**Subject: RESPONSE TO CITY OF ROSEMEAD – GEOLOGICAL REPORT
REVIEW DATED SEPTEMBER 13, 2010 BY ECI**
Rosemead Park Aquatic Center
9155 E. Mission Drive
Rosemead, CA
Converse Project No. 10-31-284-01

Reference: "Geotechnical Study Report, Rosemead Park Aquatic Center, 9155 E. Mission Drive, Rosemead, California, Converse Project No. 10-31-284-01, dated September 3, 2010"

Subject: **RESPONSE TO CITY OF ROSEMEAD – GEOTECHNICAL REPORT
REVIEW DATED SEPTEMBER 16, 2010 BY ZEISER KLING**
Rosemead Park Aquatic Center
9155 E. Mission Drive
Rosemead, CA
Converse Project No. 10-31-284-01

SITE PLAN AND BORING LOCATION MAP

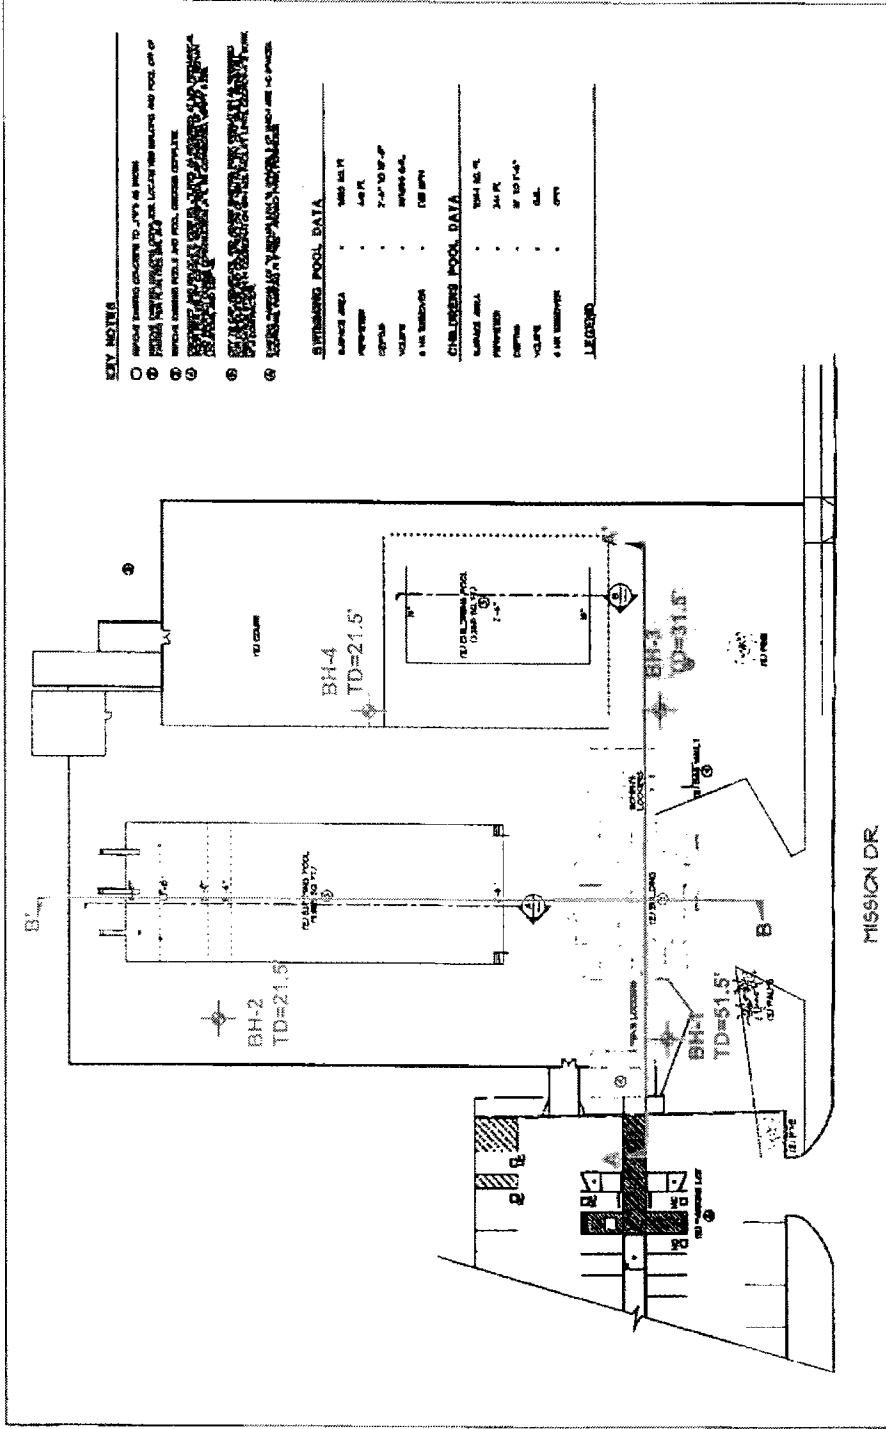
Comment No. 3: *The Consultant Site Plan, Drawing No. 2 is unclear. Please provide a more legible plan and indicate the location of the proposed development elements in comparison to existing elements.*

3. The consultant site plan, Drawing No. 2 is unclear. Please provide a more legible plan and indicate the location of the proposed development elements in comparison to existing elements.

Response to Comment No. 3: An updated Geotechnical Study Report will be issued with a more legible copy of Drawing No. 2, *Site Plan and Boring Location Map*. In addition, the updated report will include a drawing that illustrates the boring locations with respect to the planned site re-development. Copies of Drawing No. 2a, *Site Plan and Boring Location Map*, and Drawing No. 2b, *Proposed Improvement Plan* are provided at the end of this response letter.

GEOLOGIC CROSS SECTION A-A'

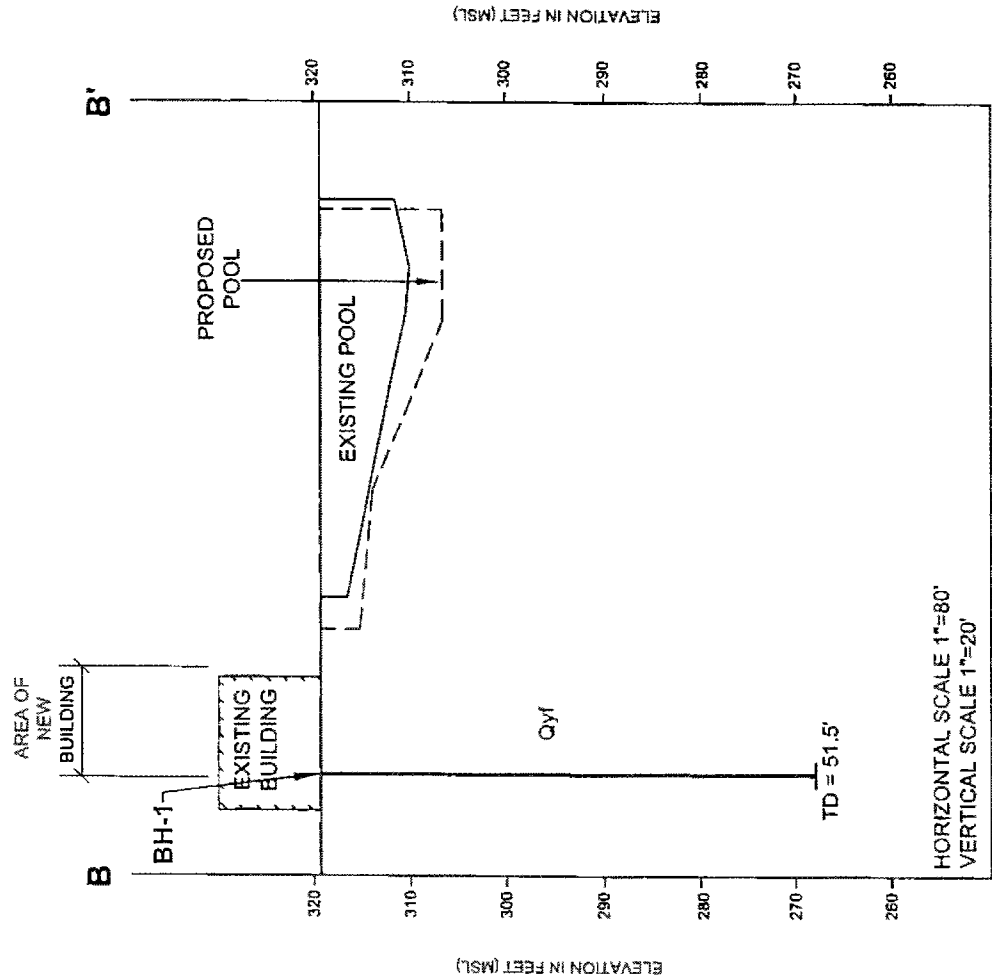
Comment No. 4: *Please provide cross sections to illustrate depth of pool elements in relationship to proposed structures and existing structures that will remain.*

4. Please provide cross sections to illustrate deep of pool elements in relationship to proposed structures and existing structures that will remain.
5. The consultant states in the main portion of the report that groundwater was not encountered to the depths explored (51.5 feet) and that the highest historical groundwater was at 30 feet, yet in Appendix C the consultant states that groundwater was encountered at 13 feet and that the highest historical groundwater level was less than 5 feet. Please clarify.

Response to Comment No. 4: We understand that the existing swimming pool, pool decking, community building and site walls will be demolished. Site re-development will include a 40-meter by 25-yard swimming pool, 4,471 square feet bathhouse building, 8,300 square feet of shade structures, and 7,200 square feet of solar panels. Drawing No. 3a, *Geotechnical Cross Section A-A'* and Drawing No. 3b, *Geotechnical Cross Section B-B'* have been prepared to illustrate the approximate depth of existing pool elements in relationship to the proposed site re-development. The vertical scale has been exaggerated to better illustrate the existing versus planned improvements. These drawings are provided at the end of this response letter and will be included in our updated Geotechnical Study Report.
